GRADING AND EROSION CONTROL PLAN
APPALOOSA HIGHWAY 24 SUBDIVISION FILING NO. 2
EL PASO COUNTY, COLORADO

APPALOOSA HIGHWAY 24 SUBDIVISION
FILING NO. 1A
COLORADO SPRINGS, COLORADO
COVER SHEET

Markup Summary

APPALOOSA HIGHWAY 24 SUBDIVISION
FILING NO. 1A
COLORADO SPRINGS, COLORADO
GRADING AND DRAINAGE PLAN

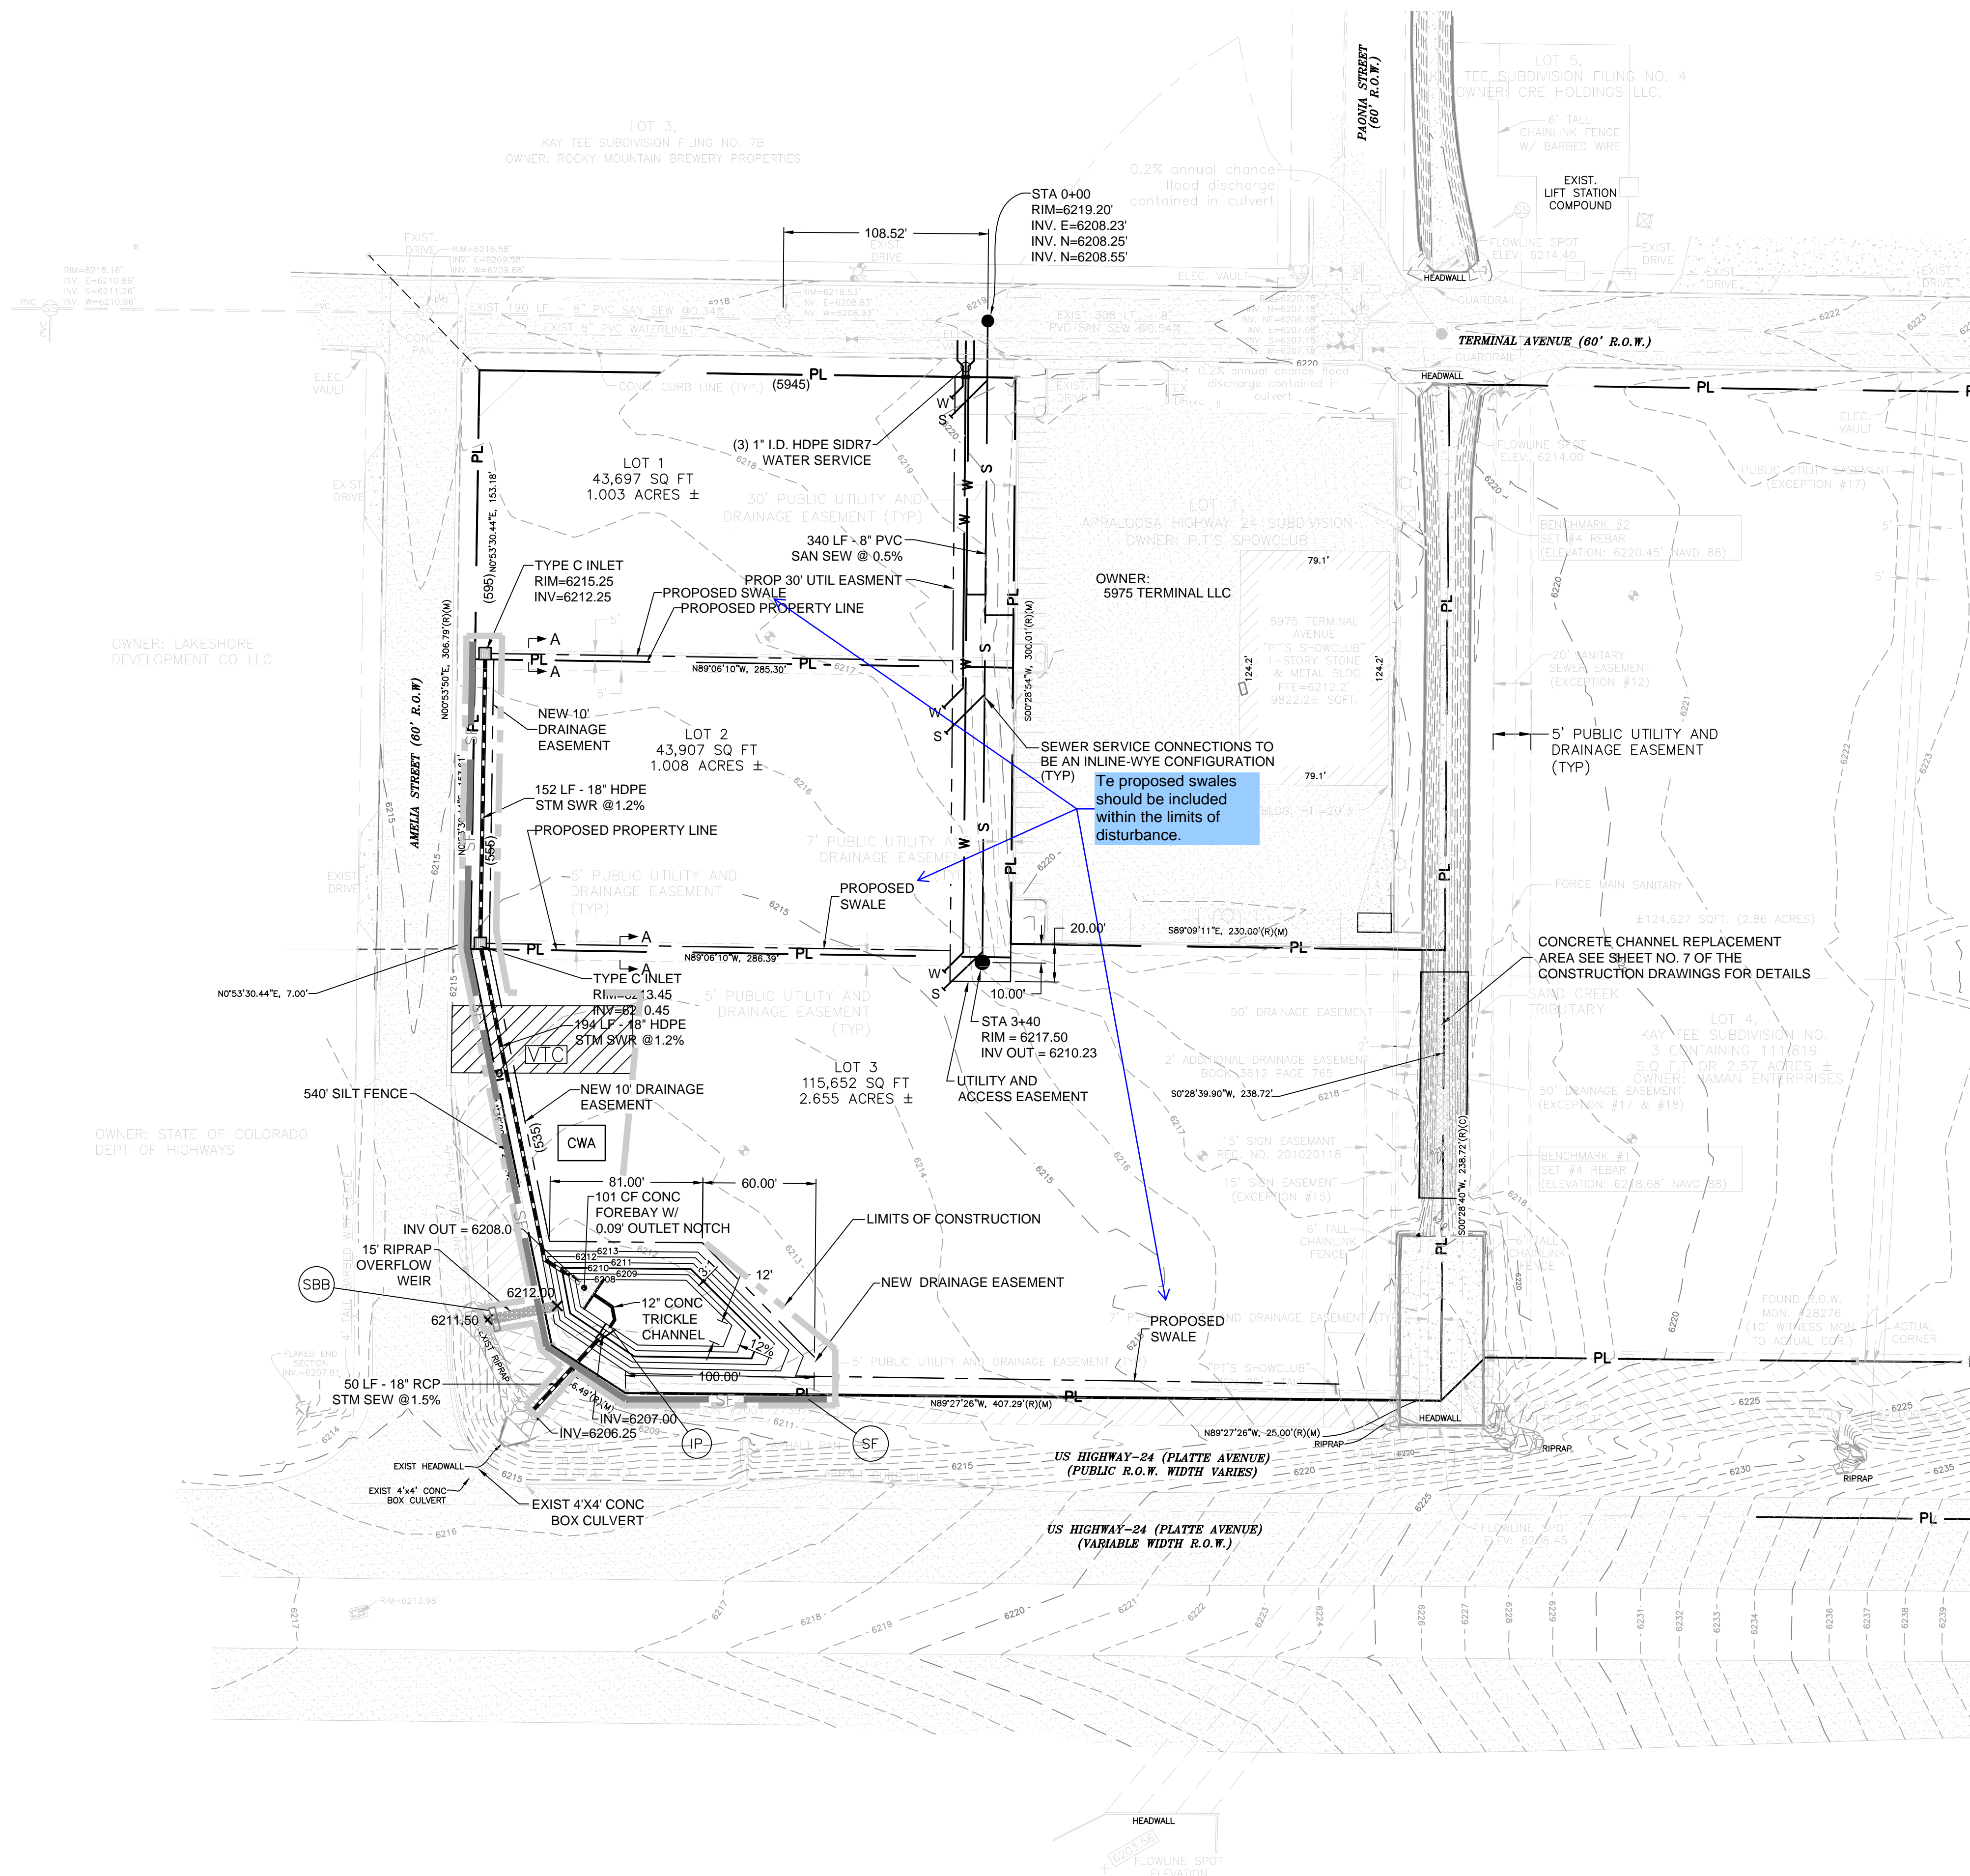
Provide a detail for the proposed swales showing depth, width, slopes, geometry, etc.

Provide a detail for the proposed swales showing depth, width, slopes, geometry, etc.

Te proposed swales should be included within the limits of disturbance.
